TRANSMITTAL COVER SHEET

DATE: 25 June 2024
TO: ALL PLAN HOLDERS OF RECORD
FROM: HUNTER SWATEK, AIA, PROJECT MANAGER
PROJECT: RAINBOW CITY RECREATION CENTER
GMC PROJECT NO. ABHM230021
RE: ADDENDUM NO. 4 AND
ACKNOWLEDGEMENT OF RECEIPT OF ADDENDUM NO. 4

ADDENDUM NUMBER 04

**PROJECT: RAINBOW CITY RECREATION CENTER
GM&C PROJECT NO. ABHM230021**

G8 AMPHITHEATRE SECTION
SCALE: 1/2" = 1'-0"

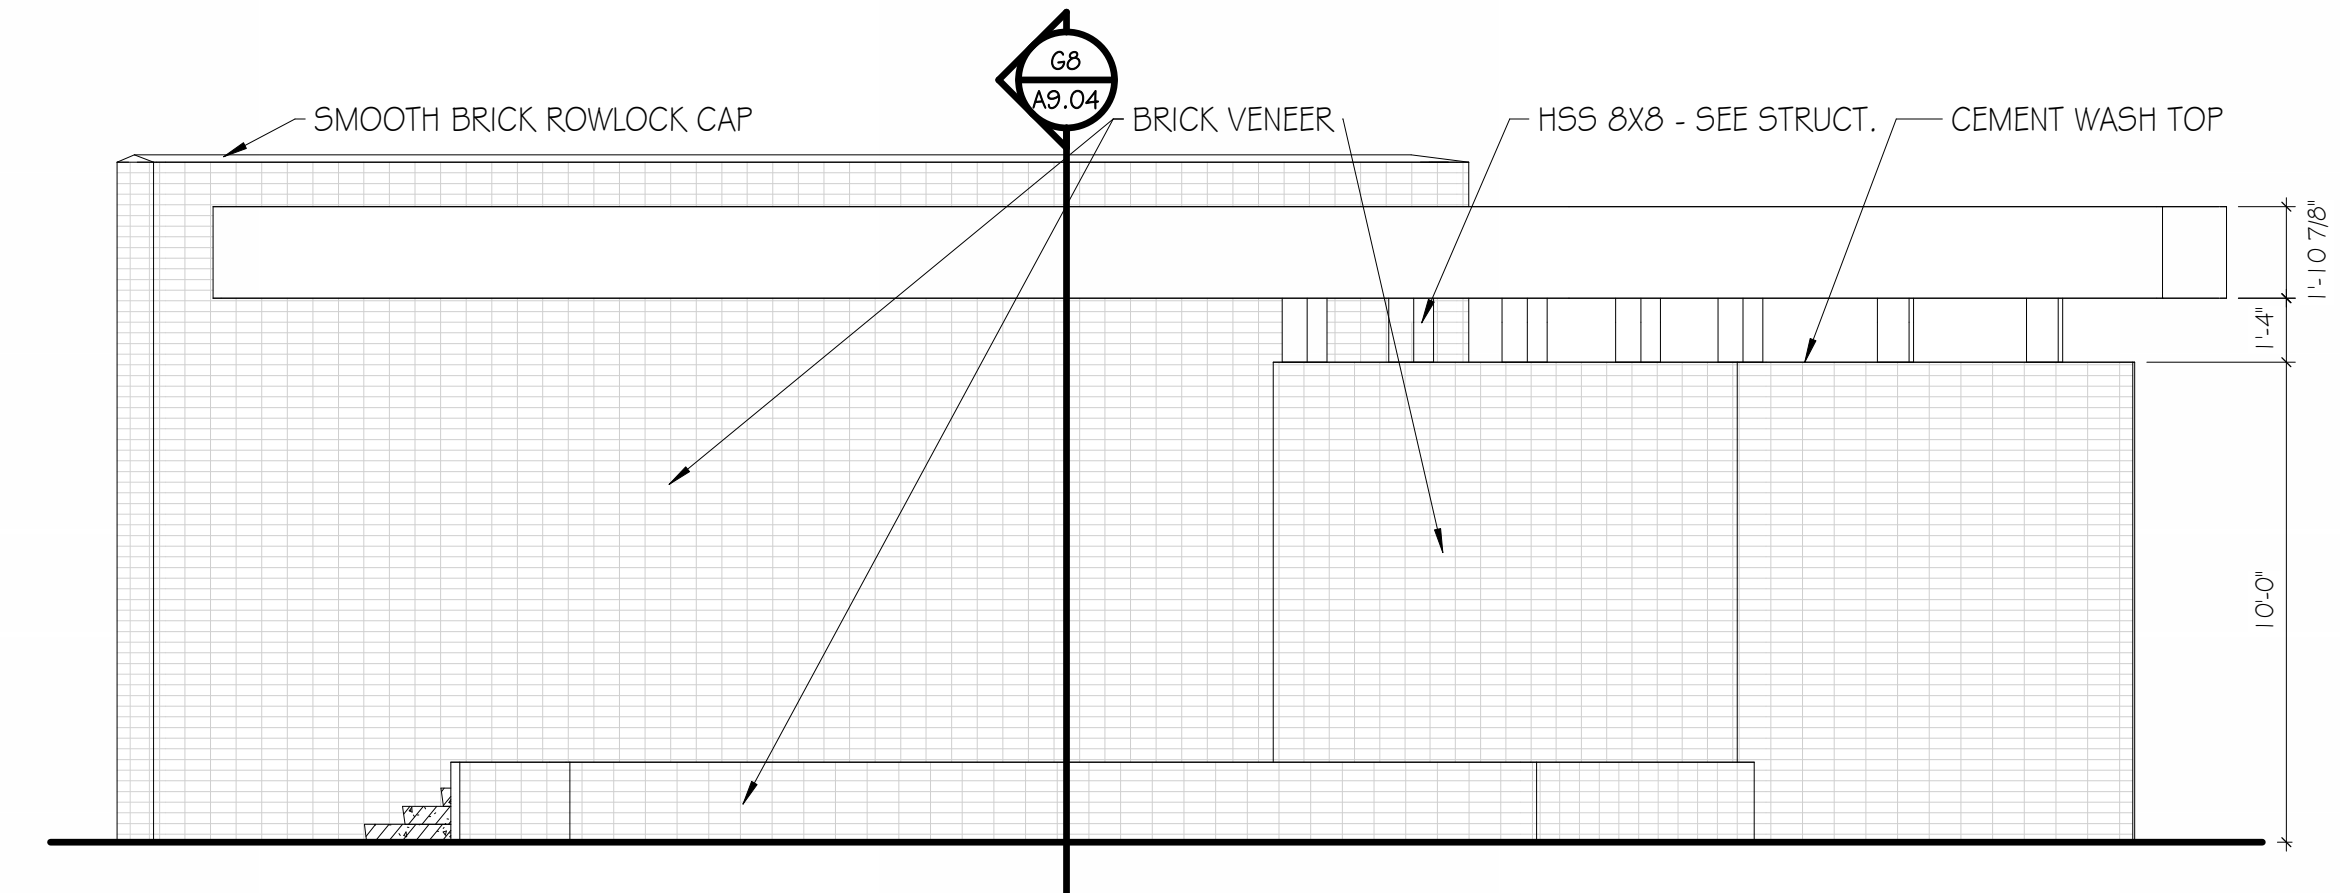
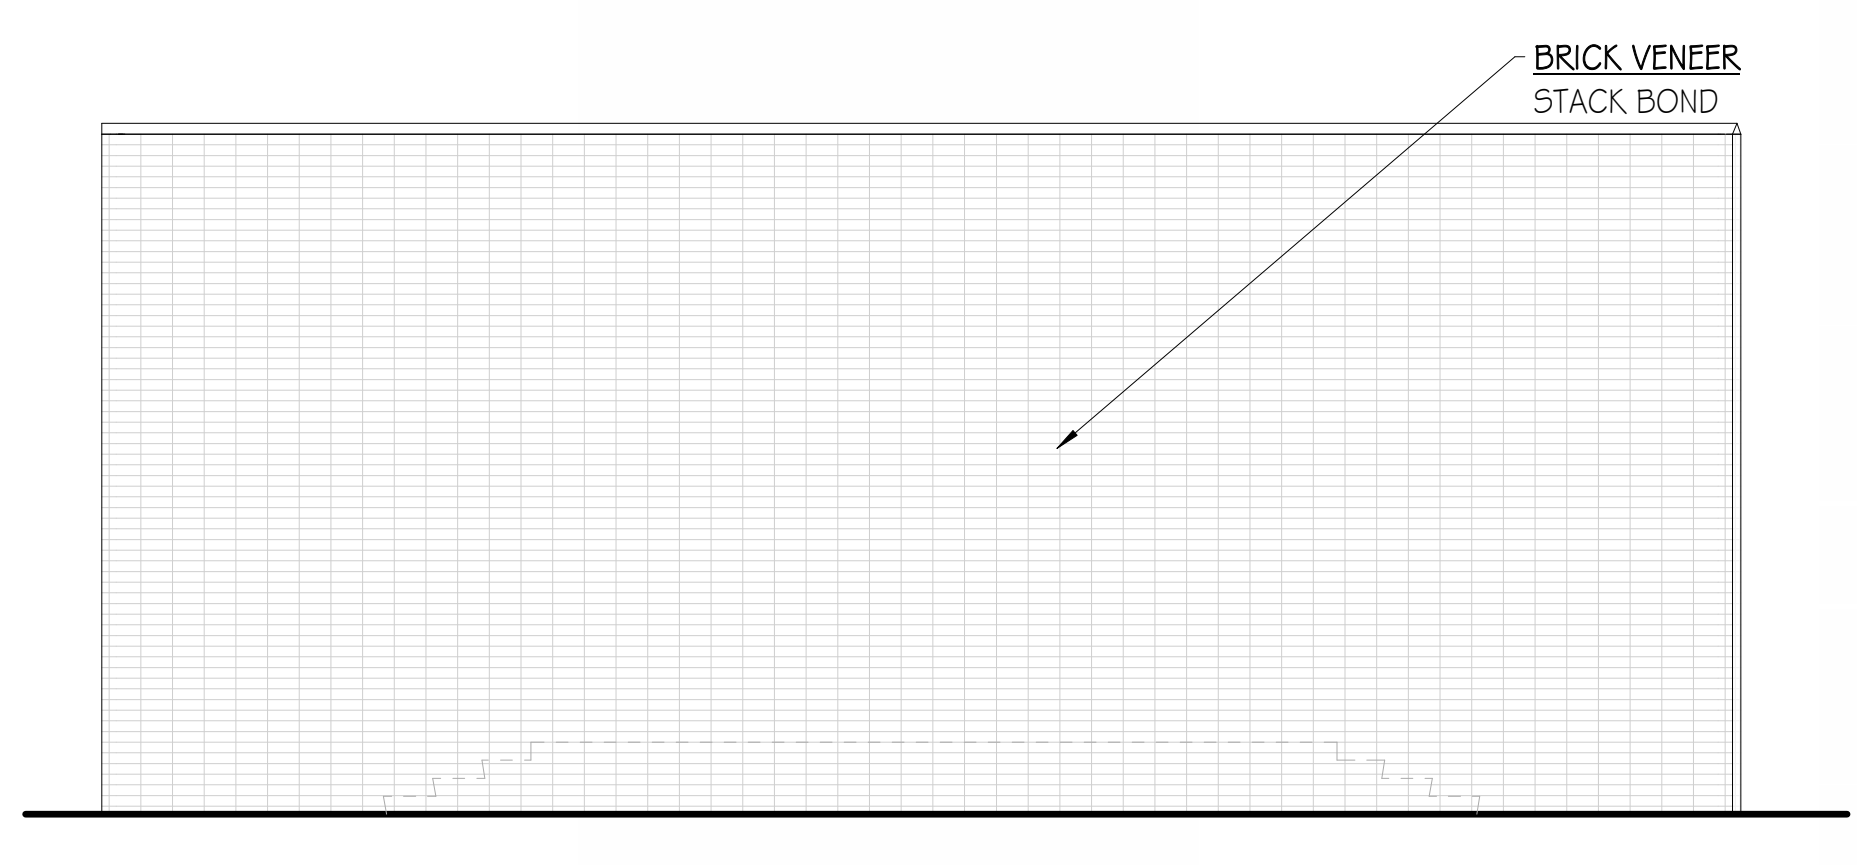
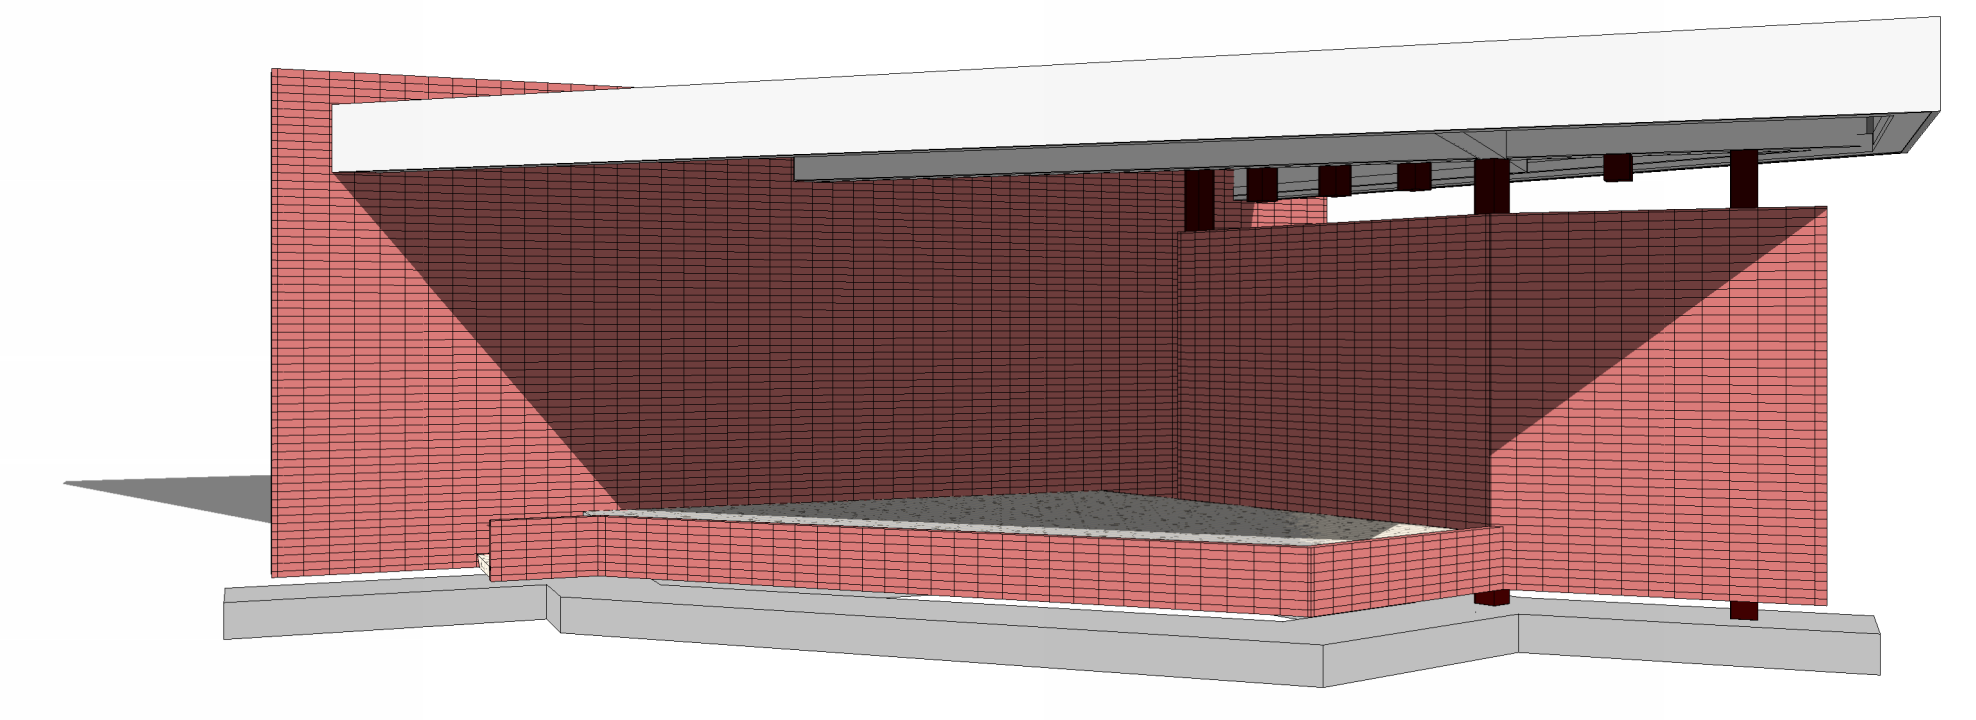
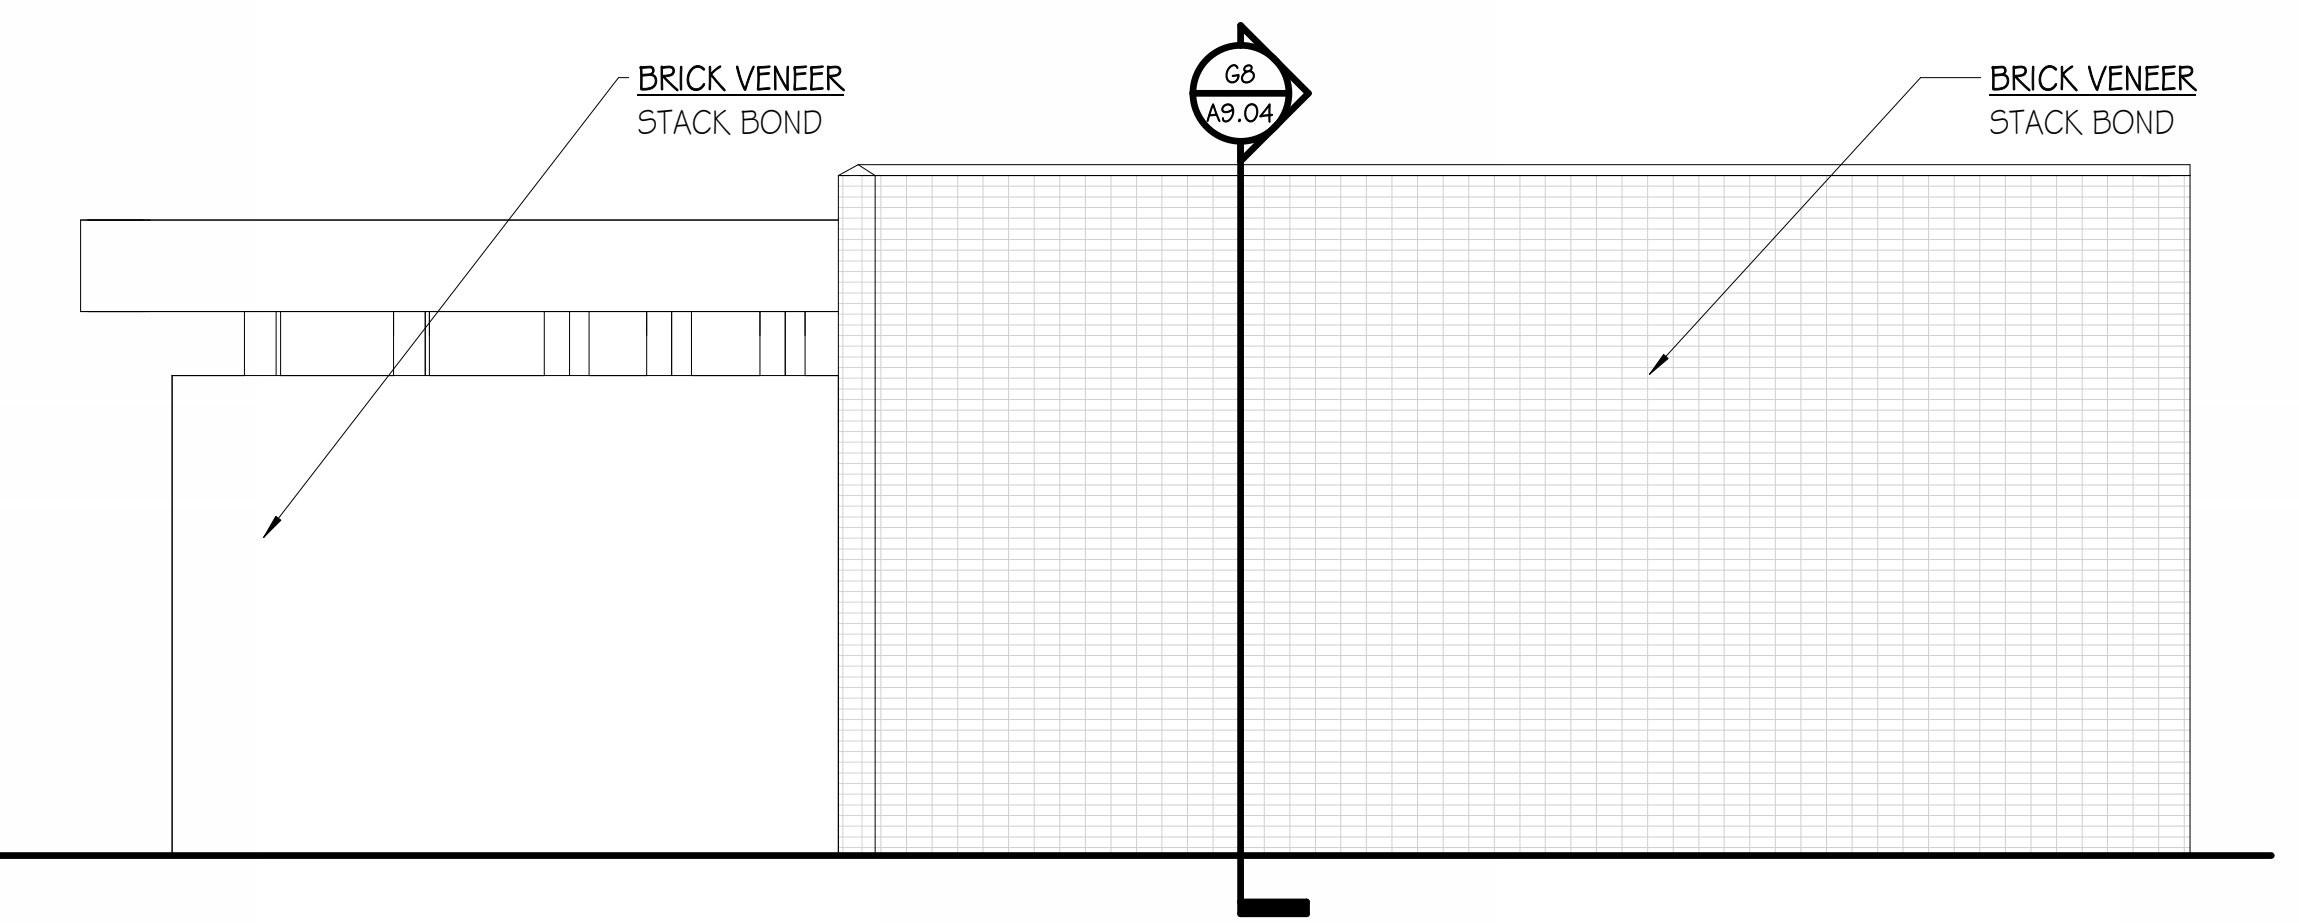
- a. ADDED TV Enclosure
- F. **A7.06** – Gym Interior
 - a. ADDED TV Enclosure
- G. **A7.07** – Interiors Multi-Purpose
 - a. REVISED Acoustics Pattern
- H. **A9.04** – Amphitheatre

- a. ADDED Scuppers
- I. **C-101** – Site plan
 - a. REVISED Transformer Pad Location
- J. **C-201** – Grading Plan
 - a. REVISED Note
- K. **L1.01** – Materials Plan

L1.01

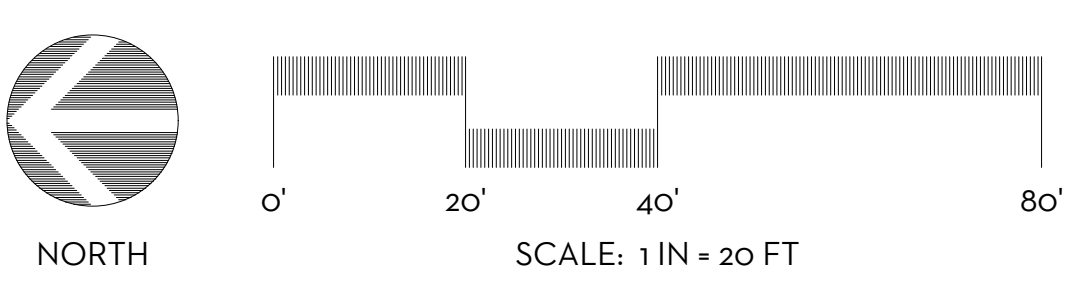
- a. REVISED Transformer Pad Location
 - b. REVISED Notes
- L. **L1.02** – Materials Plan Alternate
 - a. REVISED Transformer Pad Location
 - b. REVISED Notes

FLOOR AND FOUNDATION PLAN
 S2.01

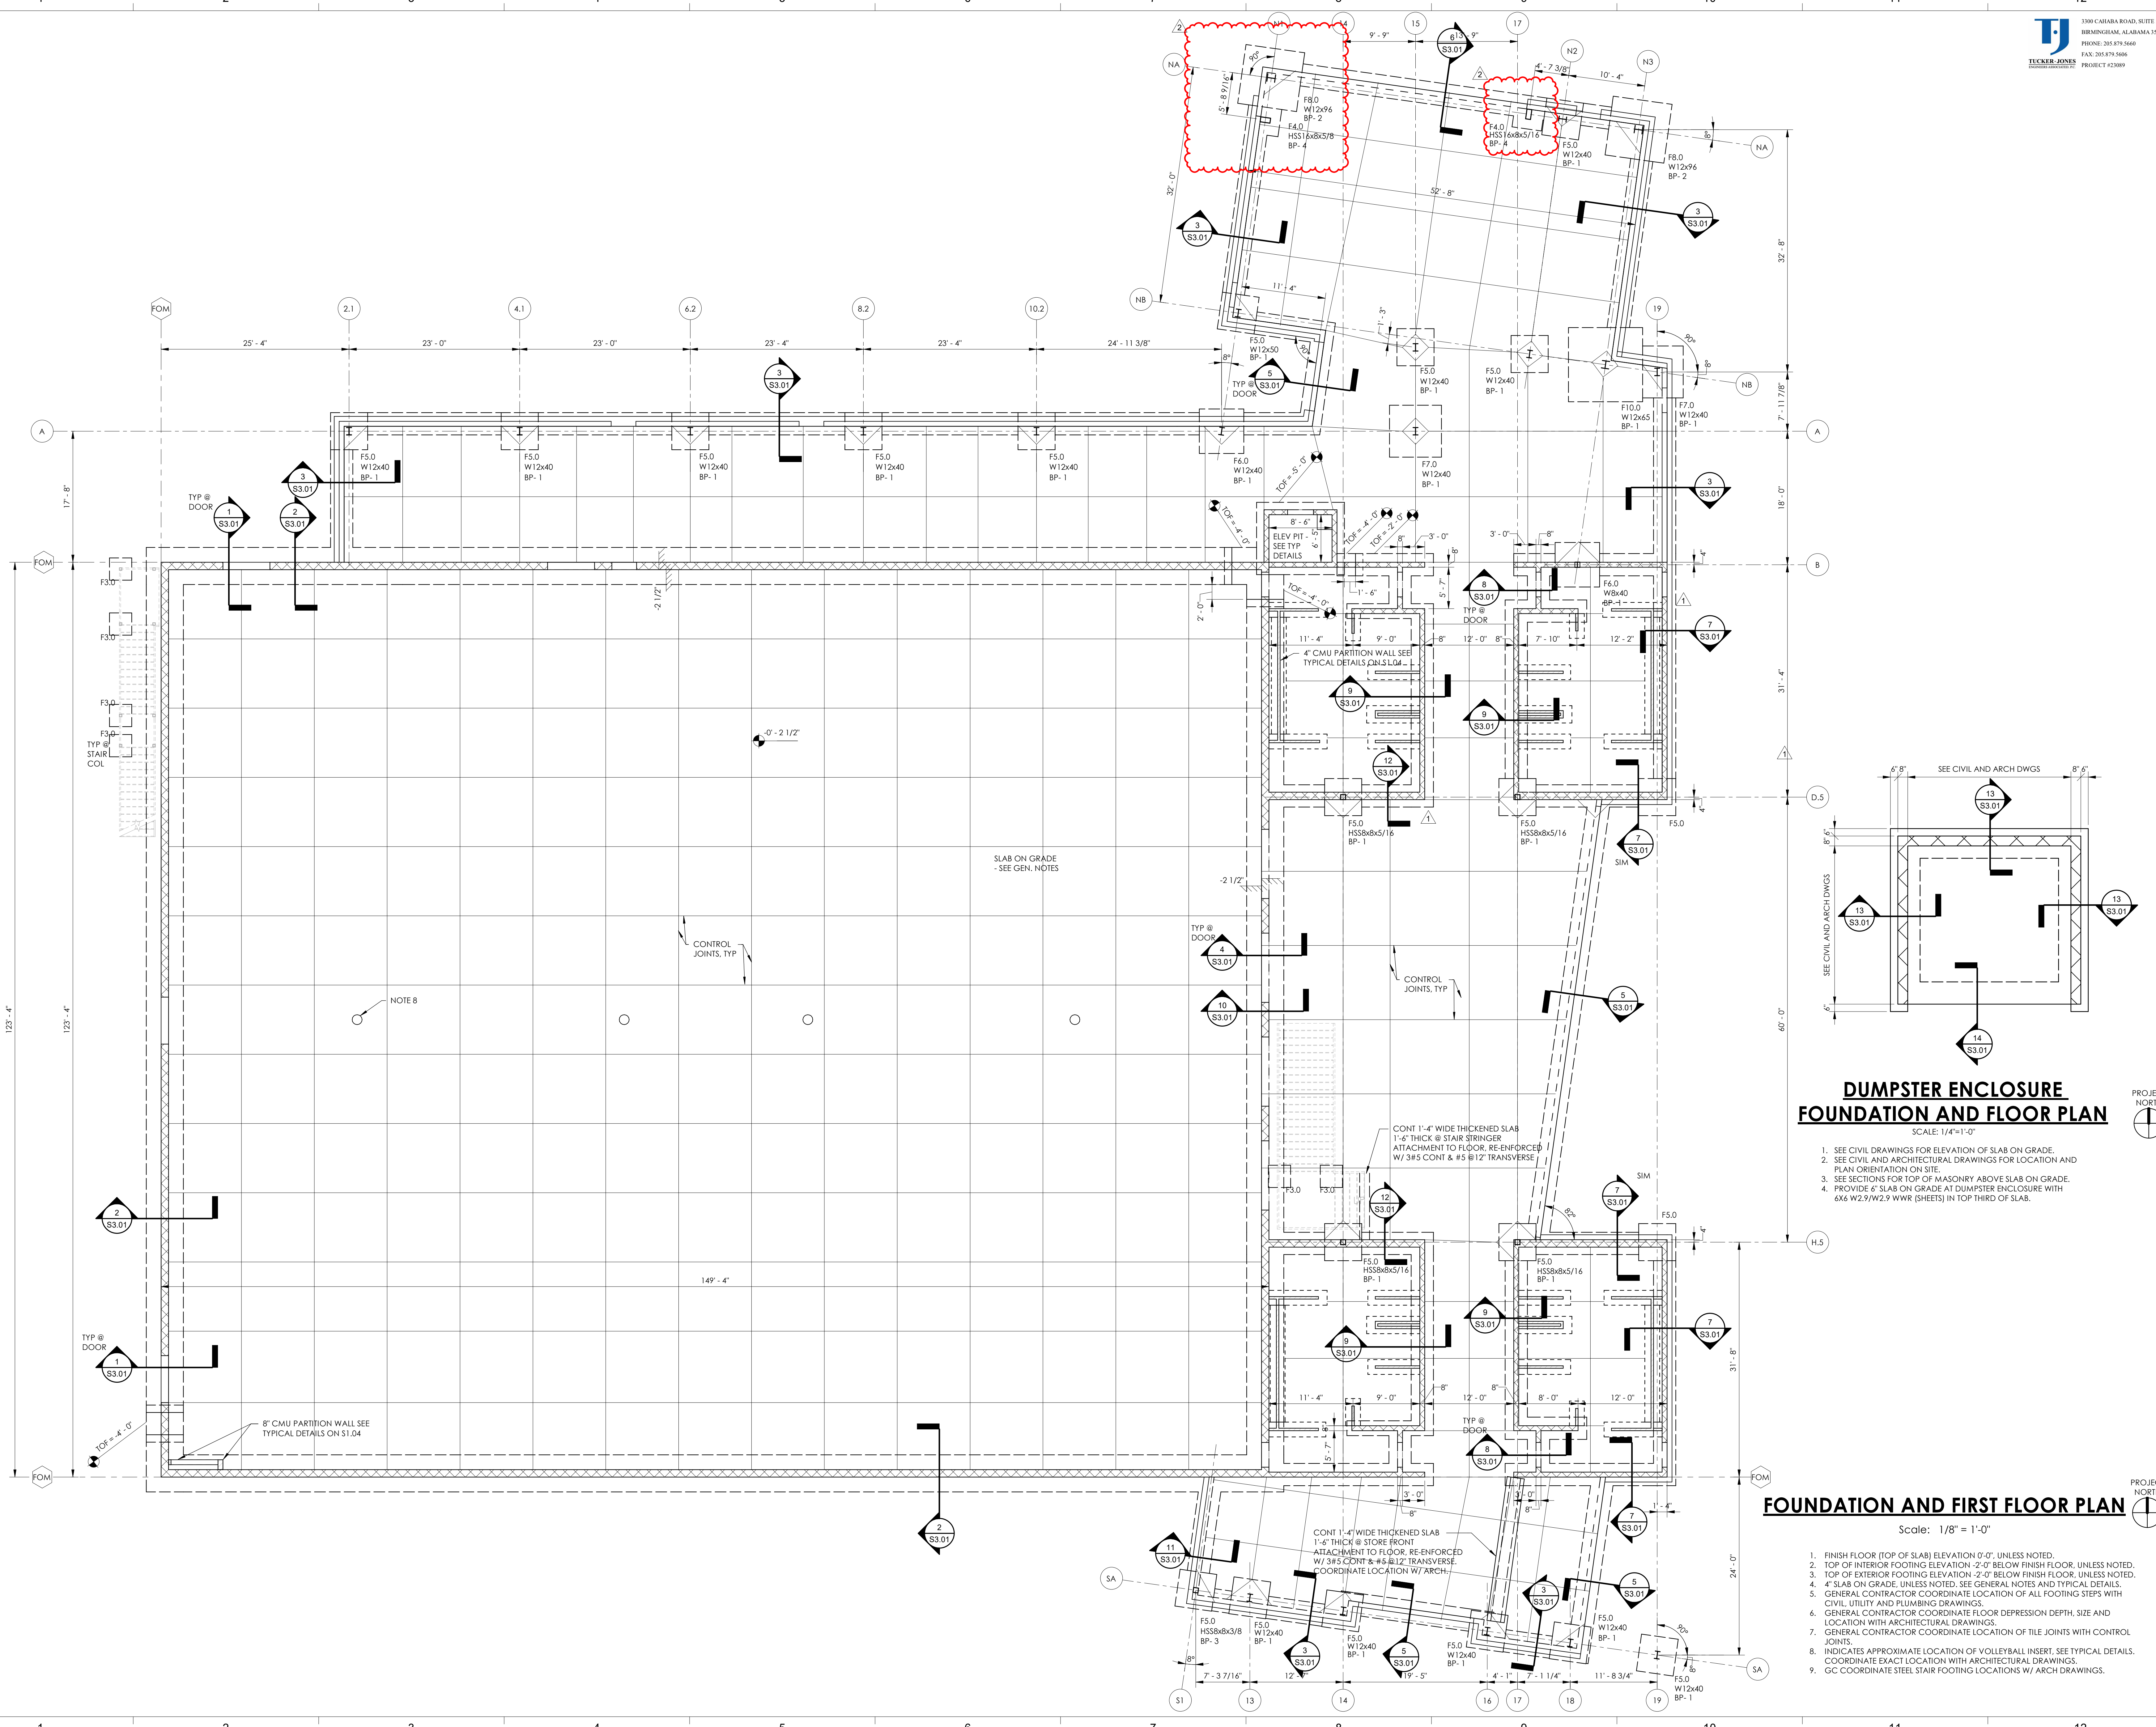
- M. **L5.01** – Landscape Plan
 - a. REVISED Transformer Pad Location
- N. **S1.06** – Typical Details
 - a. REVISED Footing Schedule
- O. **S2.01** – Floor and Foundation Plan

- a. REVISED Footings @ Multi Purpose
- P. **S2.02** – Second Floor Plan
 - a. ADDED Horizontal Structural Support for Curtain Wall
- Q. **S2.03** – High Roof plan
